## PRODUCTION ANNOUNCEMENT: NEW IMPROVED OPTIONAL HOLDER

**Date:** 2026-02-18

### MAIN PURPOSE & CHANGES

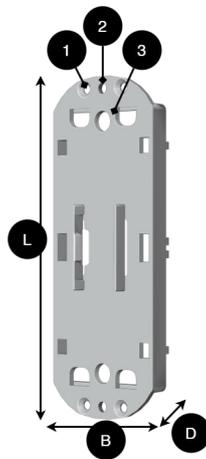
Milletechnik introduces a new optional card holder with a focus on stability and space saving.

**Material:** Modified material for increased rigidity

**Design:** The depth has been reduced to save space in the enclosure.

**Holes:** Three new screw holes per short side for more stable mounting.

**DIN rail:** The option of DIN rail mounting has been removed by default.

Designation	Dimensions	
L, B, H	Length x Width x Depth	107 x 40 x 13 mm
1	Hole on short side, outer x 2	3 mm
2	Holes on short side, middle	3.4mm
3	Holes in on short side, inside	3.4mm
